Proposed Revisions to a Standard Plans Index

Index Number: 700-120
Sheet Number (s): All
Index Title: Enhanced Highway Signing Assemblies

Index Number: 700-120

Index Title: Enhanced Highway Signing Assemblies

TABLE OF CONTENTS:

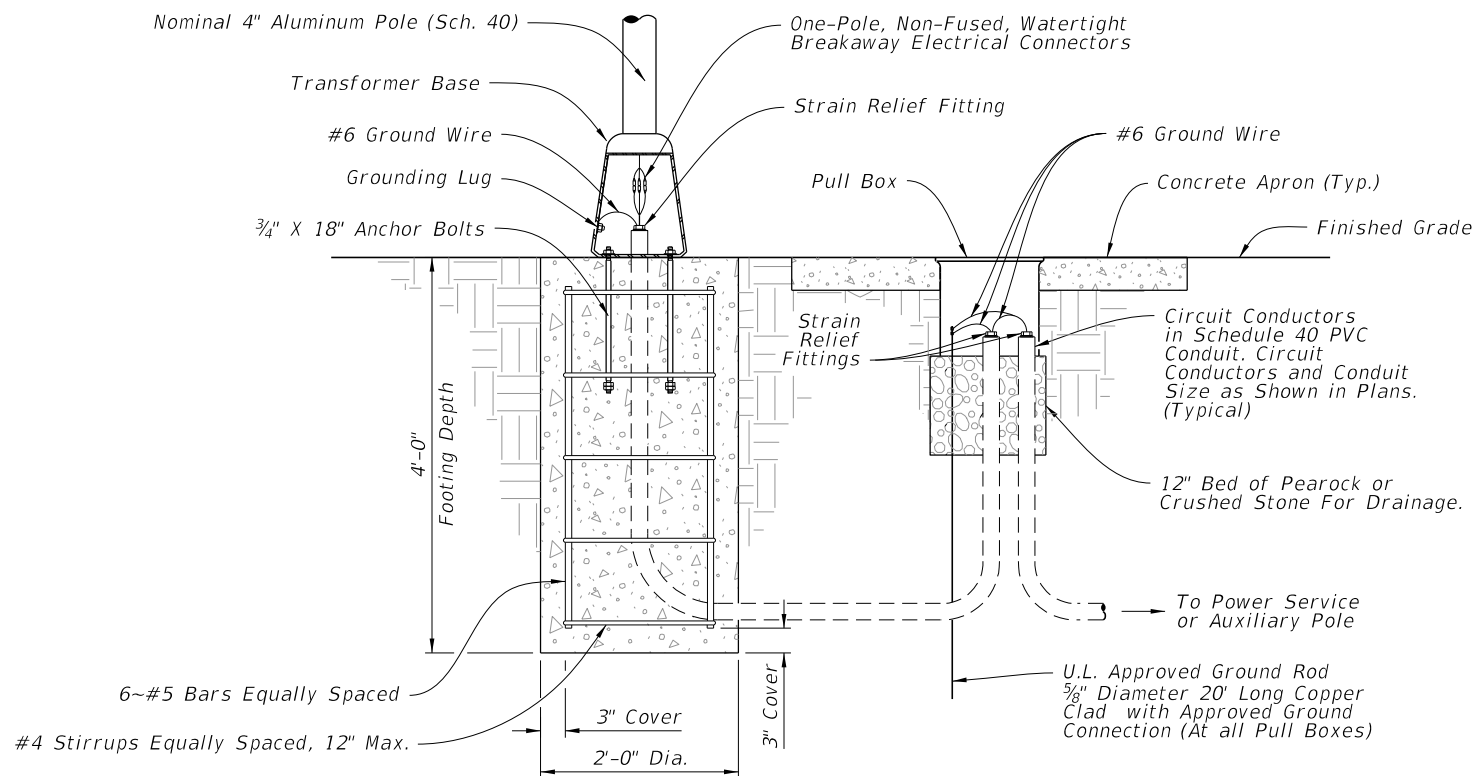
All Sheets: Renumber
Sheet 1: Added New Sheets to Table of Contents.
Sheet 3: New Sheet - Spread Footing Foundation.
Sheet 12: New Sheet - Roadside Sign Assembly-9.
Sheet 13: New Sheet - Roadside Sign Assembly-10.
Sheet 14: New Sheet - Roadside Sign Assembly-11.

ADDED NEW SHEETS

NEW SHEET 3

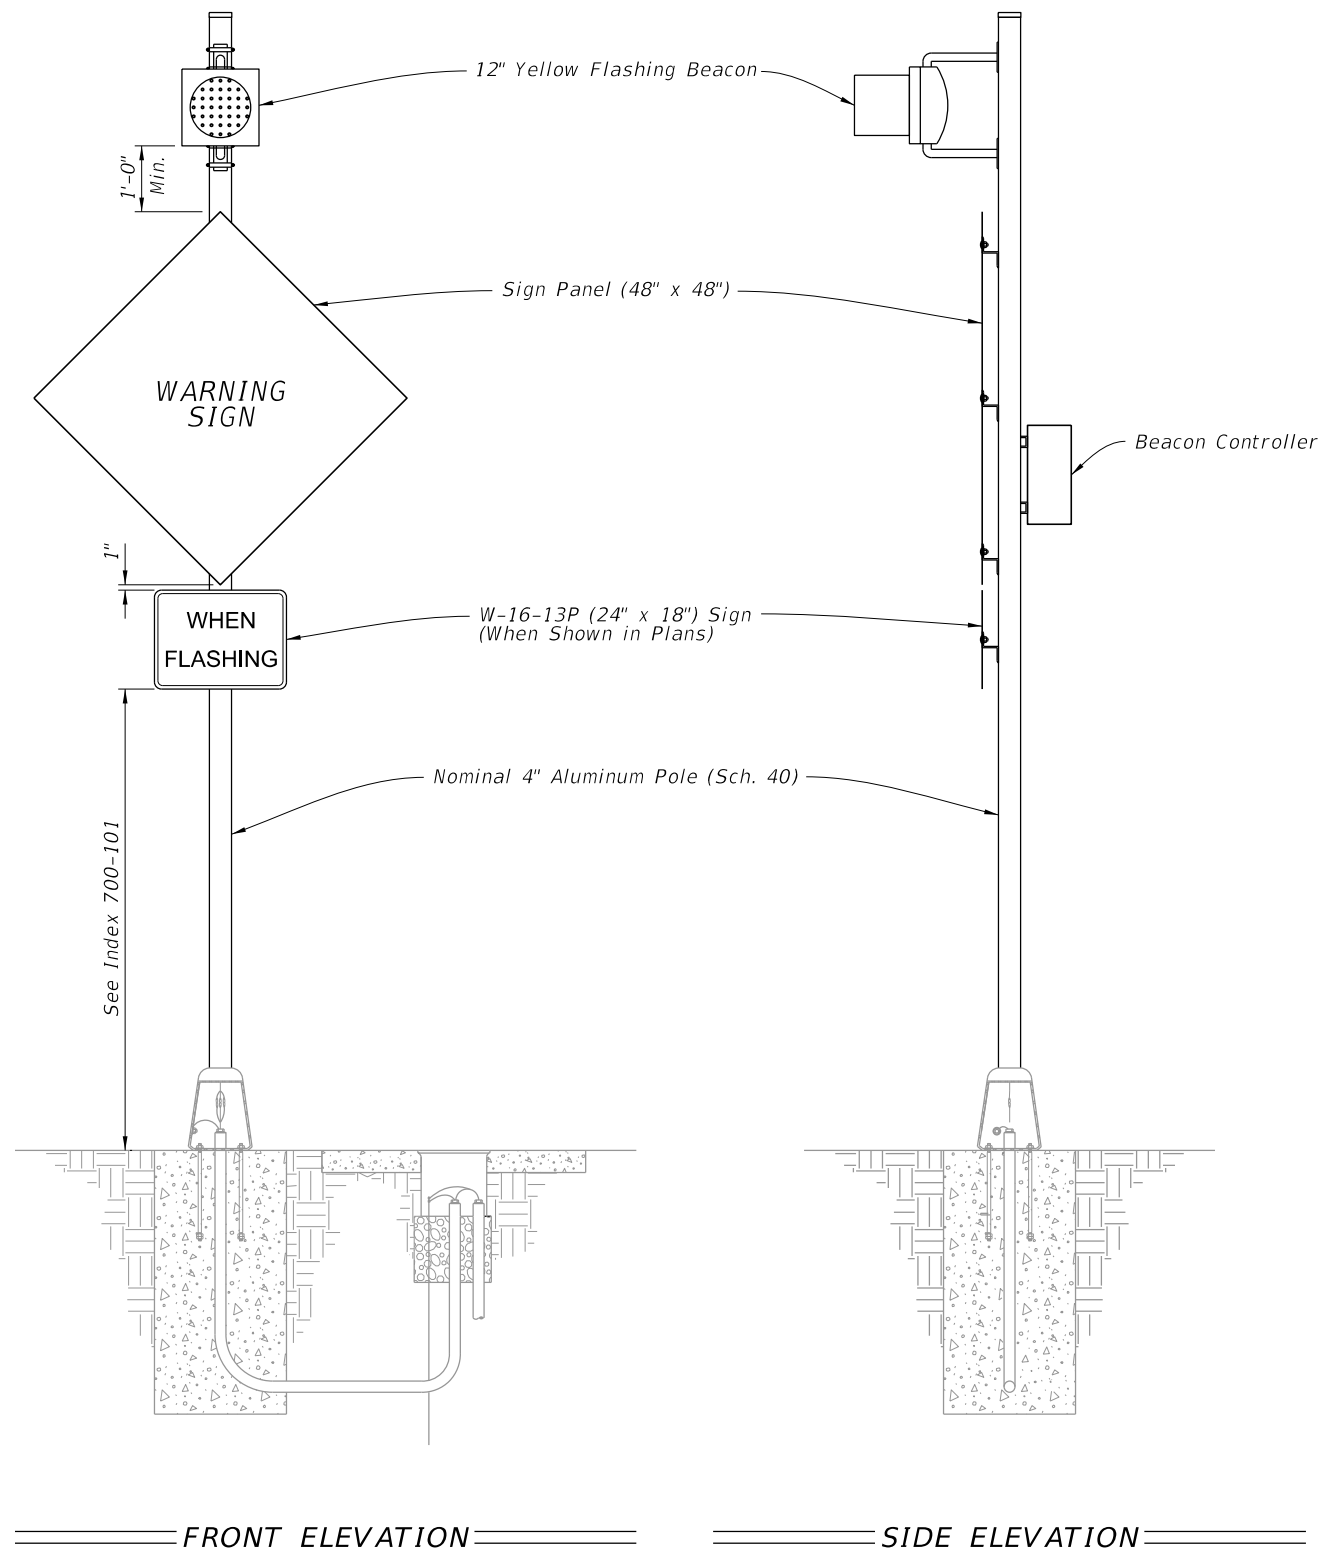
The districts have requested a spread footing foundation option be added.

OVERHEAD SIGN ASSEMBLY

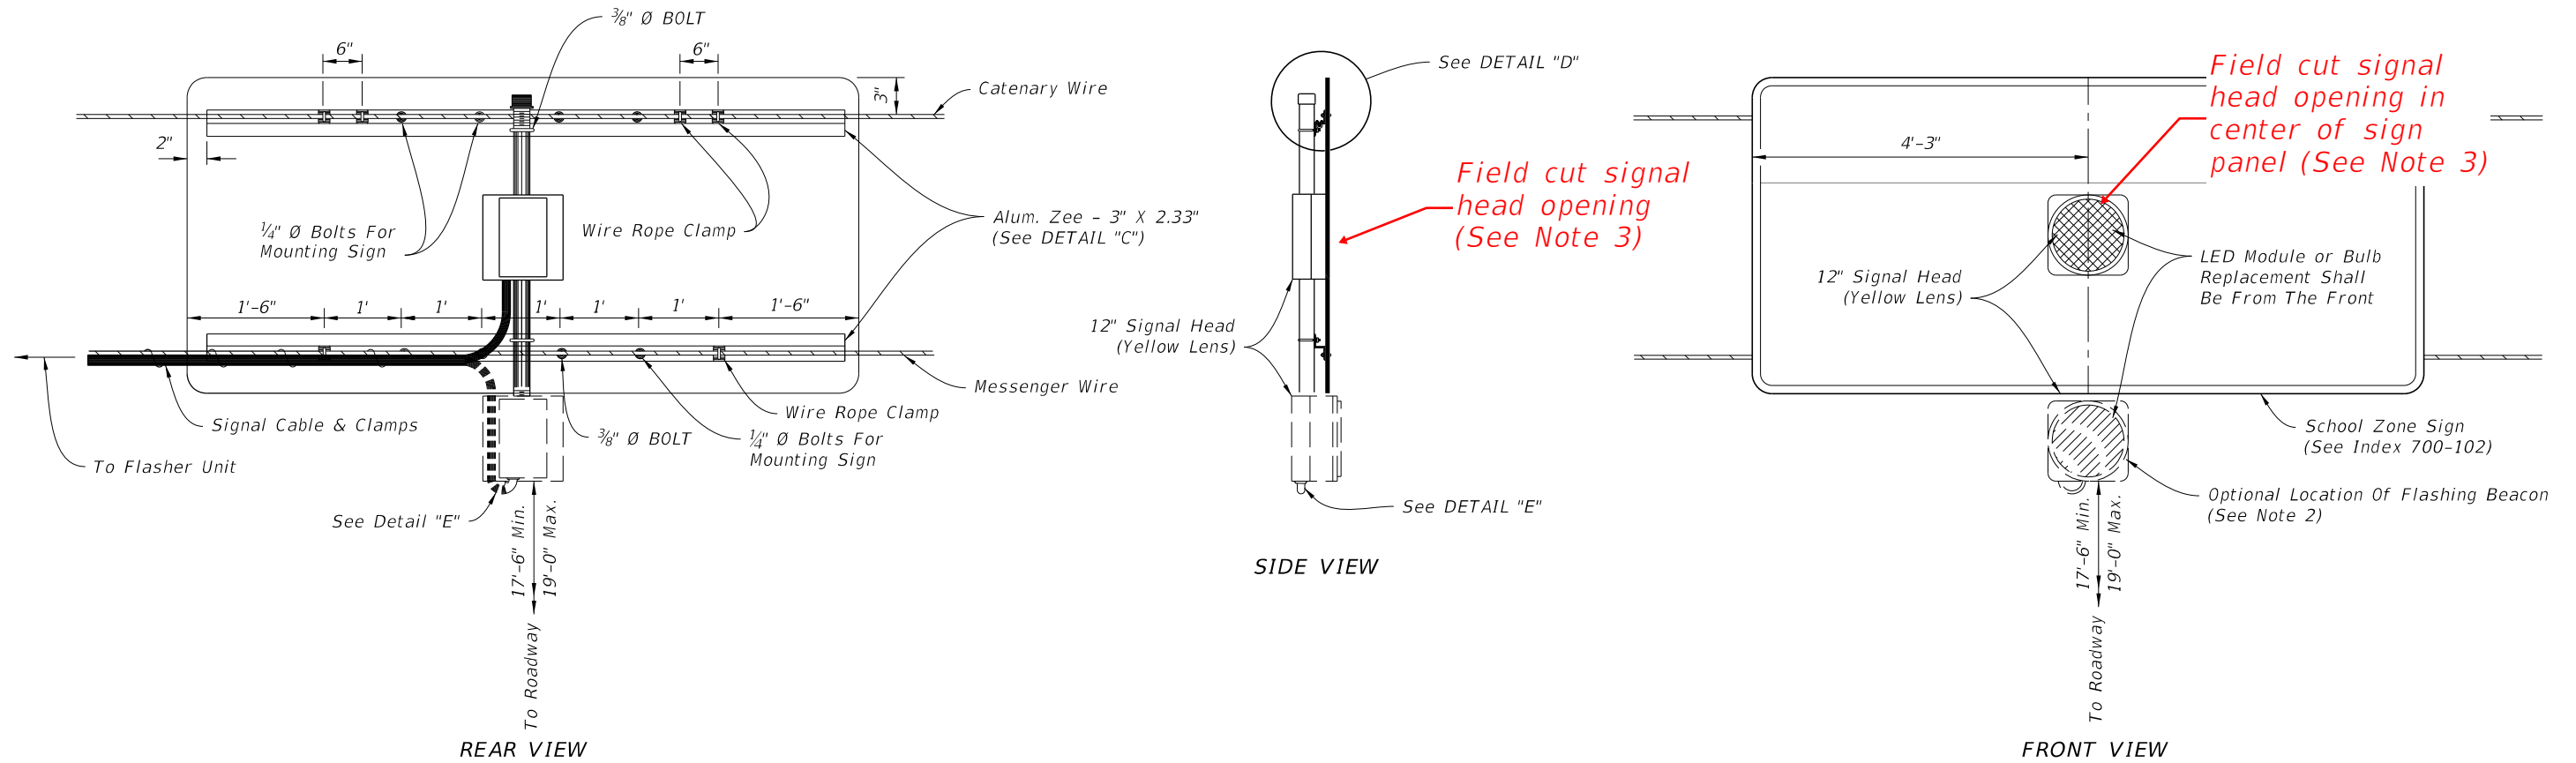
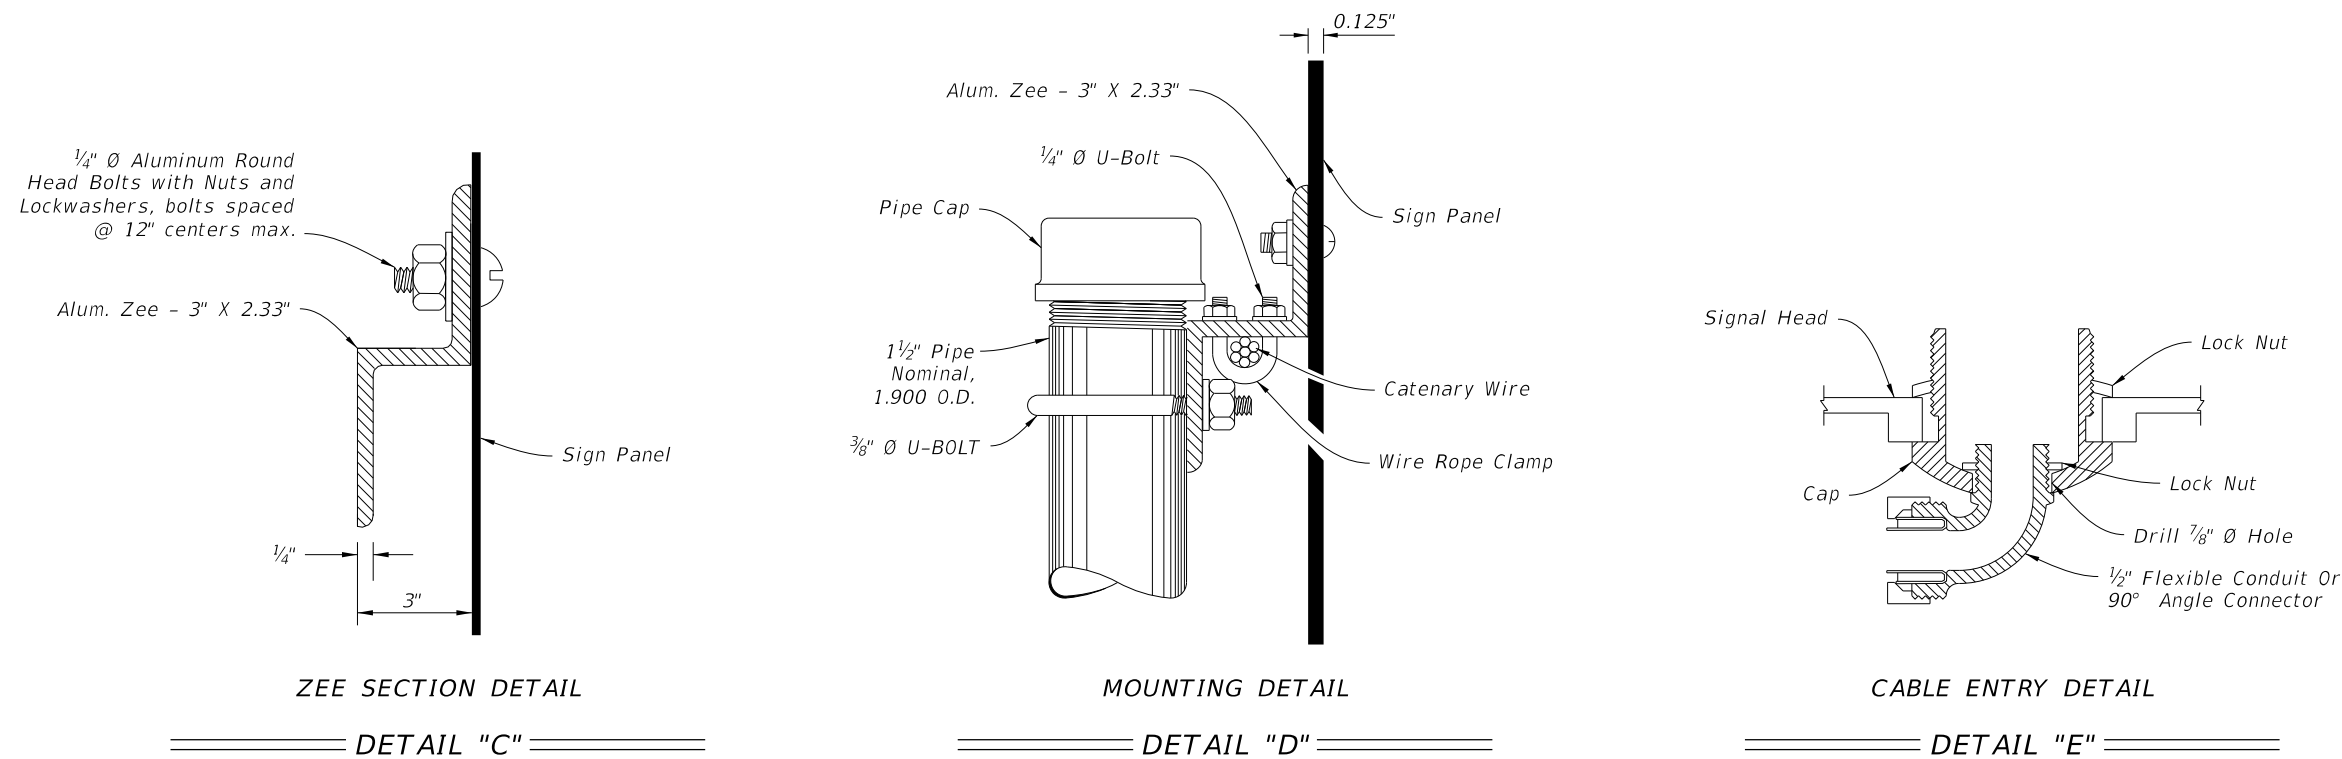
Added note 3 "Opening for 12" signal head shall be done in the field in accordance with the manufacturers specifications".

Added 2 call outs one on side view "Field cut signal head opening (See note 3) and the other for front view "Field cut signal head opening in center of sign panel (See Note 3).

3. Field install the opening for 12 inch signal head in accordance with the manufacturers specifications

OVERHEAD SIGN ASSEMBLY

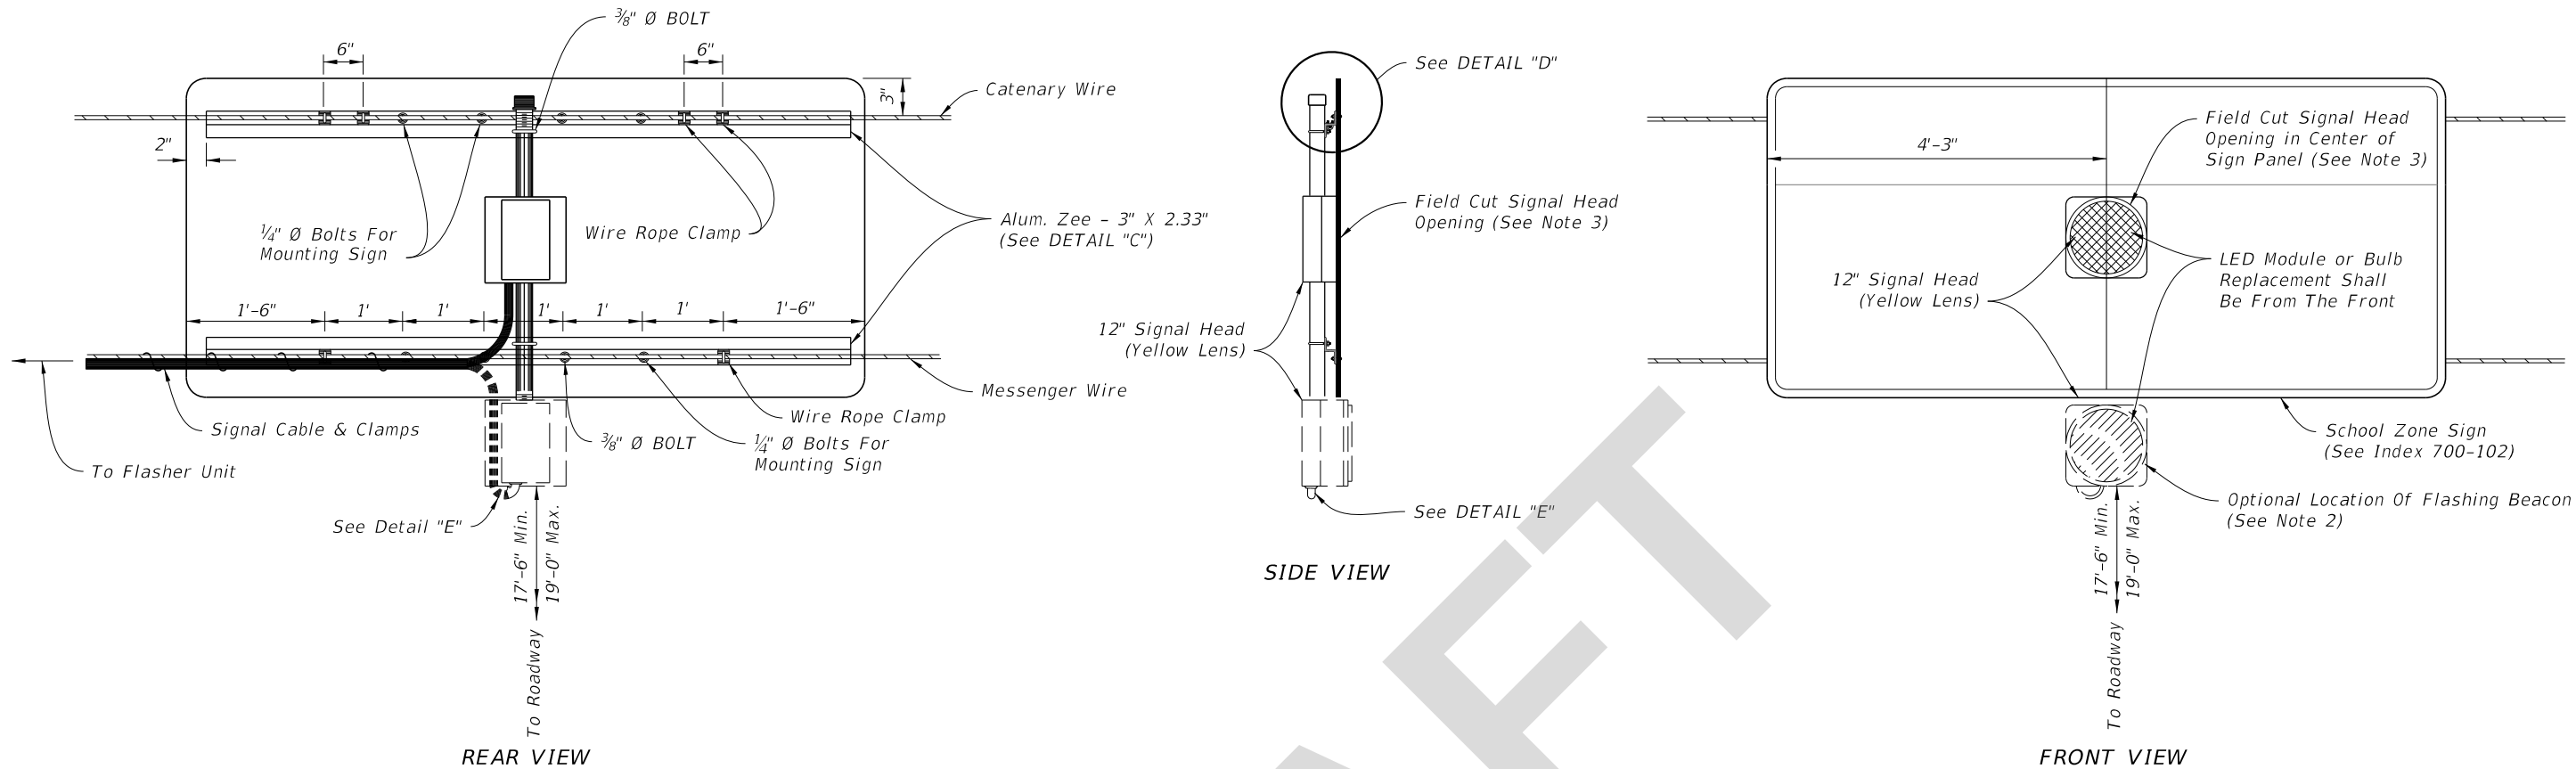
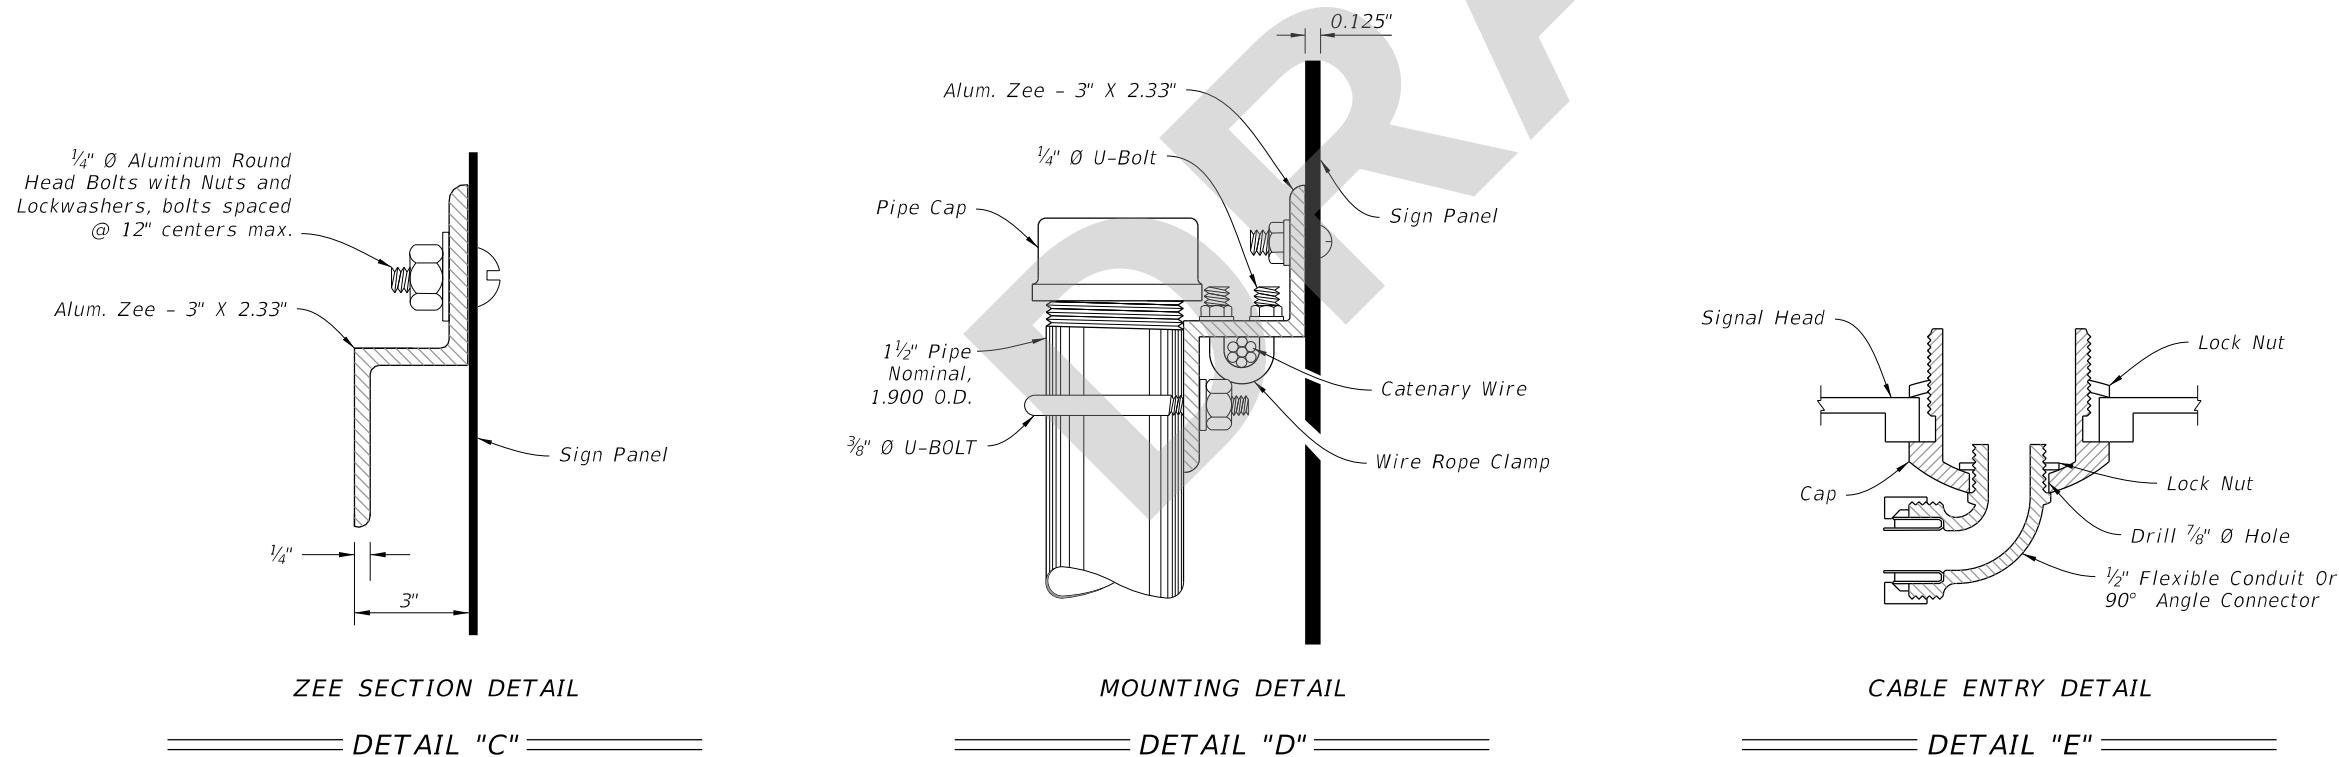
- Flasher unit and cabinet to be placed on the strain pole supporting overhead sign assembly or on service pole. The flasher unit not to overhang private property or sidewalk.
- Optional flashing beacon will be called for in the Plans. They may be placed within or below the panel, or face to the rear.
- Field install the opening for 12" signal head in accordance with the manufacturer's specifications.
